TRANSPORTATION ACCESS CONSIDERATIONS

The Building Committee has held or attended numerous meetings to listen to community concerns and considerations about transportation options for review by the High School design team. This memo is the design team's response to a list of these concerns compiled by the Building Committee. It categorizes responses by A) options evaluated and recommended, B) options evaluated and not recommended, and C) options that could be optionally implemented in the future.

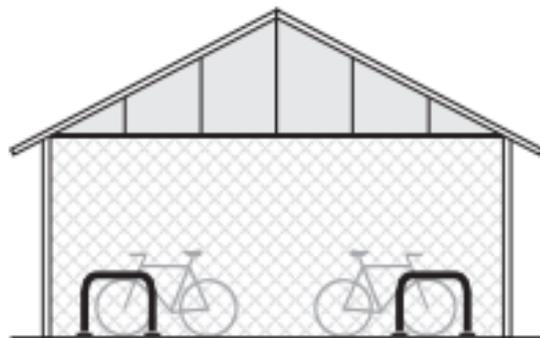
1. Develop safe pathway to future Alexander underpass
 - a. This would be a valuable priority if the Alexander underpass gets built (we understand it has been approved, but funding needs to be secured).

- b. The site plan has been adjusted to have paths and crosswalks connecting the Alexander underpass to the school entries. Additional crosswalks and connecting paths could be added once this connection is made.

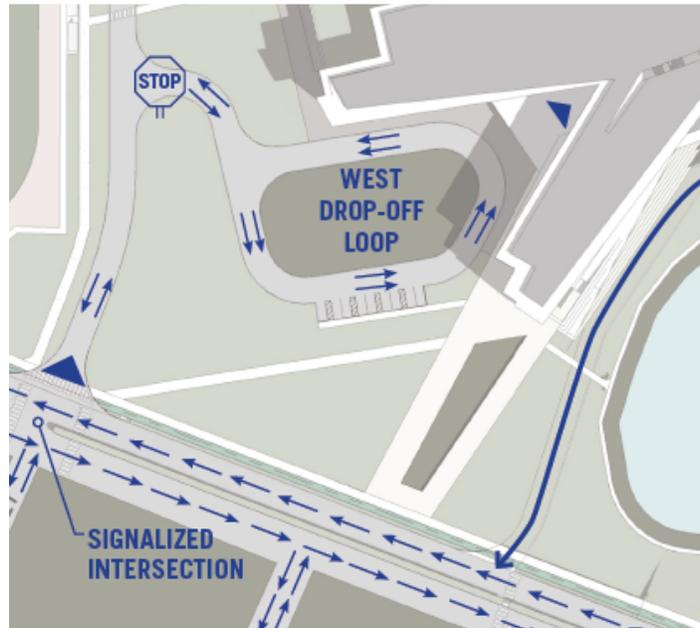
- 5. Move drop off at the center of the front entrance to provide more space for students to congregate
 - a. Site plan has been updated to allow a space for students to gather at the front of the campus and to ensure adequate pedestrian connections separate from driveway access connections. See image grab of working design below:

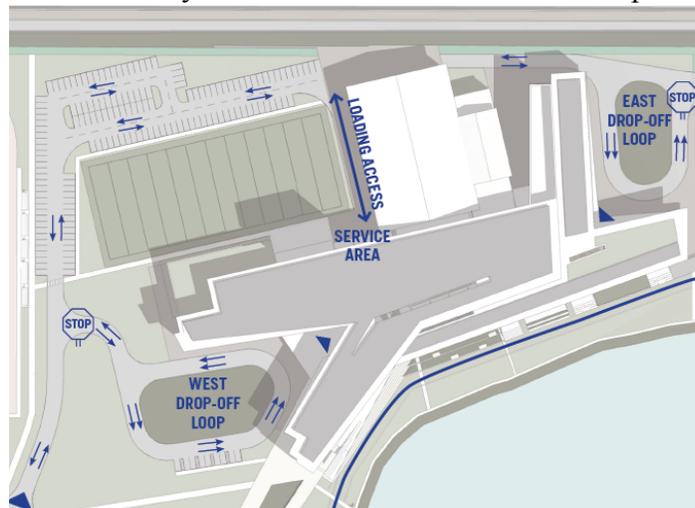
- 6. Create ample space behind Field House for two traffic lanes, Community path, and loading dock turns
 - a. All functions are accommodated, as shown in site plan below – site plan was adjusted to ensure all of these were addressed (see below)

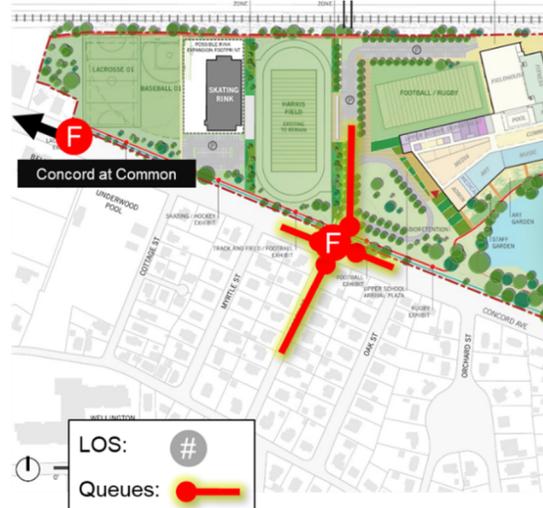
13. Make one-way traffic through campus east to west
- a. The team is not proposing one-way traffic through campus anywhere as it creates congestion and safety issues for all users. Two-way helps disperse any potential congestion by providing options, and multiple options also reduces emergency response delays and provides maximum flexibility for emergency personnel.
 - b. The one-way driveway is demonstrated to create dangerous conditions and conflicts by forcing all cars through the same entry and same exit, concentrating problems without an alternative.
 - c. If the access drives to school parking are one-way, this would also add unnecessary local congestion for drivers who circle the campus to access a parking spot passed along the way.

- i. Goden & Concord, future AM peak, no signal:

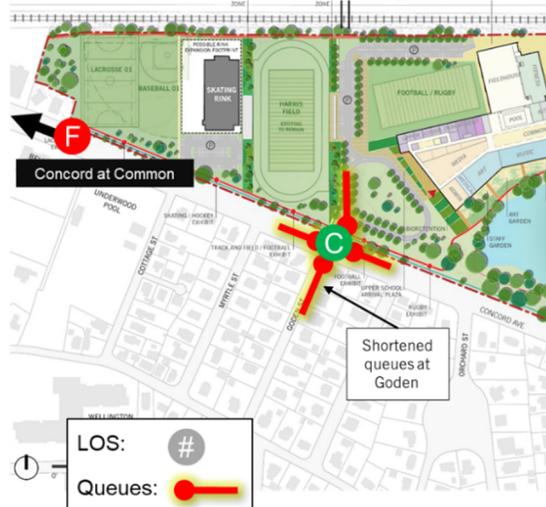
14. Don't add a 4-way stop at Goden and Concord

- a. A signalized intersection has been proposed as it improves operations and safety for all existing and future users by protecting left-turns, eliminating current U-turn demand, and providing lefts out of the campus (an option motorists heading south and east do not have today).
- b. See the traffic reports for more detail. Figures related to intersection function included here:
